**Revision of Manuscript Number:** IEEE-TPWRS-01391-2021, version 1 January 8, 2022  
**Journal:** IEEE Transactions on Power Systems  
**Author:** Abhishek Halder, Kenneth F. Caluya, Pegah Ojaghi, Xinbo Geng

### Response to decision:

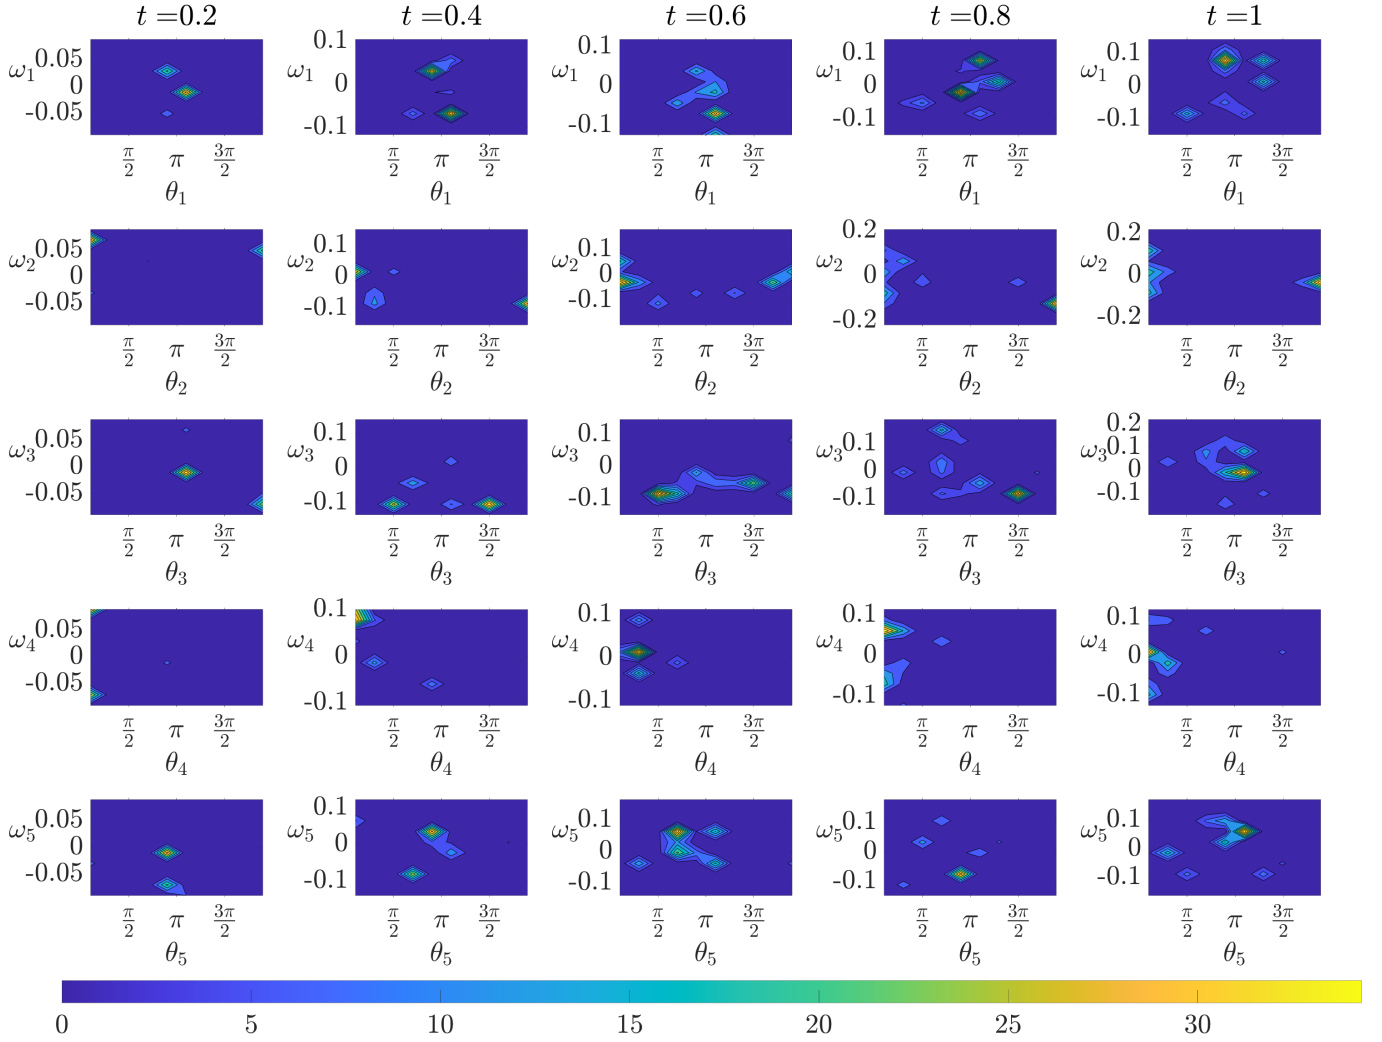
*Figures 5 and 6 are unreadable.*

Regarding the style of plots, we had considered plotting the bivariate marginals as planar contour plots (as in Fig. 1 in this rebuttal document) but decided against it because of the following two reasons.

**Response:** Thanks for this comment. In the previous version, the strict 10 page limit enforced small figure sizes. In the revised manuscript, Figures 5 and 6 are made larger. Also, the Fig. 6 in the revised manuscript shows the transient  $(\theta_i, \omega_i)$  bivariate marginals for all the five generators in Case II; the previous version showed the same only for the generator 4 (bus 6). We believe these changes have improved clarity.

*First, in our opinion, this kind of plot is scientifically misleading as they hide the fact that these bivariate marginal PDFs are not really supported on the plane, or the subsets thereof, but instead have cylindrical supports.* Our message that the proposed method explicitly accounts this manifold geometry in the computation, would be missed had we chosen to make the plots as per populist cognitive bias on behalf of the readers. That the planar plots evoke a sense of familiarity cannot be a scientific argument in favor of it.

*Second, the planar contour marginal plots require additional mental efforts from the readers to correctly parse the statistical information conveyed.* For instance, consider the fourth column, second row subplot in Fig. 1 in this rebuttal document. It is upon the reader to parse that the two high probability regions on the left and right of that subplot are actually referring to the same angular high probability region around  $\theta_2 = 0$  rad, thanks to the periodic boundary condition on the angular variable. Our philosophy of technical communication is that the onus is on the authors, not on the readers, to clarify the scientific information as correctly as possible. And yes, we are aware that many papers in the power system literature make plots in the rectangular domain ignoring the manifold nature of the support, which in our experience, continue to add pain to the graduate students and beginning researchers trying to decipher the statistical meaning conveyed in those plots. We prefer ours not be contributing to the accrual of such pain, and instead make plots that depict the variables as they are.
